**PR/0139/23**

## Record of Executive Business and Chief Executive's Order

**Reg. Reference:** SDZ22A/0017      **Application Date:** 02-Dec-2022  
**Submission Type:** New Application      **Registration Date:** 02-Dec-2022

**Applicant Name:** Cairn Homes Properties Limited

*Figure 1- Overall Street layout proposed.*

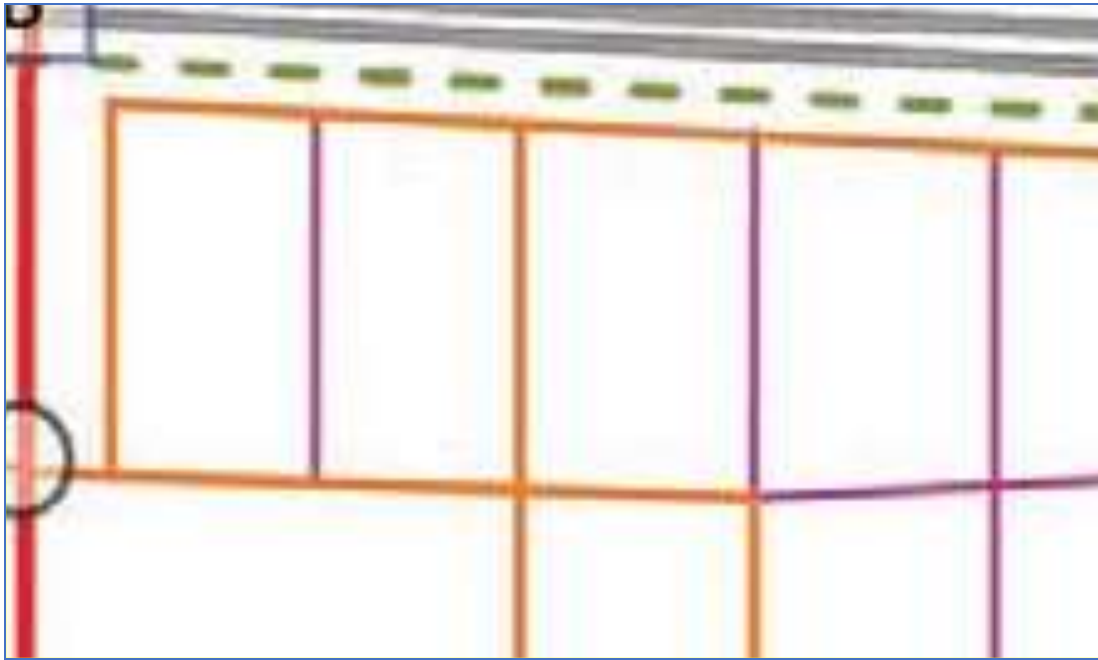
Having regard to the above, it is considered that the movement and street network proposed by the applicant is largely compliant with the planning scheme. The Roads Department has raised some concerns regarding the implementation of matters discussed in the Road Safety Audit that have not been implemented and has requested **additional information**.

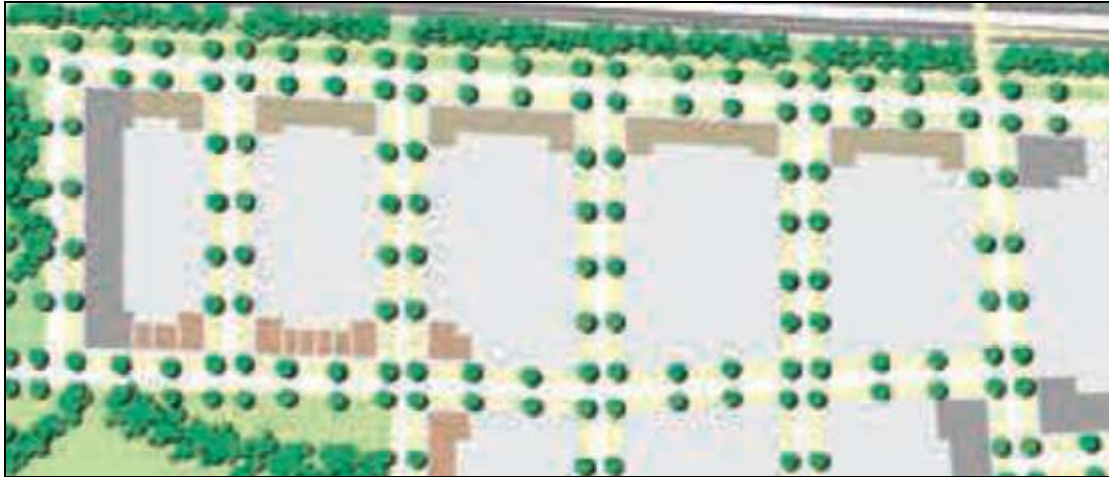
The subject application largely maintains the Local Street alignments indicated in the Planning Scheme to provide a Railway frontage to the north and Avenue frontage to the west. Concerns are raised in relation to the location of Street 16, which does not reflect the planning scheme. The planning scheme requires Park frontage on dwellings to the north east corner of the park and the location of street 16 prohibits this.

**Figure 2.2.6** Example Local Streets including Homezones (Intimate Scale)

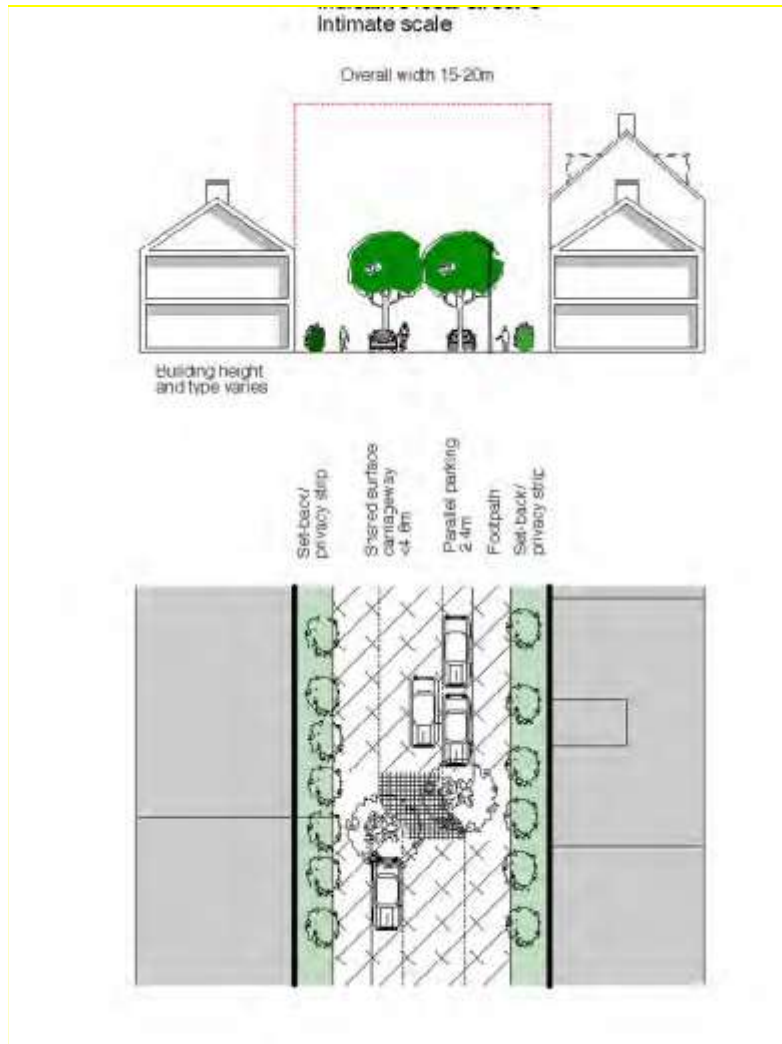
- Street 12: Generally, meets indicative local street. On curtilage parking is provided in part, which is in keeping with the scheme provided overall provision is less than 60%. There are concerns regarding the design of the area to the south of the apartment block (Block 1), which does not provide parking, nor does it provide a min. 2.5m wide footpath (only 2m is provided at this location).
- Street 13: No opposing buildings. Generally, meets indicative local street A. On curtilage parking is provided in part, which is in keeping with the scheme provided overall provision

- is less than 60%. There are concerns regarding the design of the area to the north of the apartment block (Block 1), which does not provide parking, nor does it provide a min. 2.5m wide footpath (only 2m is provided at this location).

- Street 14: No opposing buildings. Generally, meets indicative local street A. Footpath is only 2m wide and should be increased to 2.5m. An area of open space is identified at this location within the scheme, and it is also identified as a strategic green corridor. It is noted that there are significant levels of parking along this street, which are necessary for the apartments. In light of the GI designations in this area, the applicant is requested to provide for a Homezone along Street 14, along the north of the apartments to meet Street 15. There should be a significant increase in the level of planning and GI in this area also.

- Street 18: Generally, meets indicative local street A (when considered with information provided on adjacent application). The scheme requires intimate local street at this location and the applicant is requested to provide a rationale for their approach.

Where perpendicular parking is proposed, the applicant is requested to indicate that there is a 6m reversing space. The applicant is requested to provide a plan setting out the dimensions of all street widths, in compliance with the scheme, and all foot paths, carriageways and parking bays.
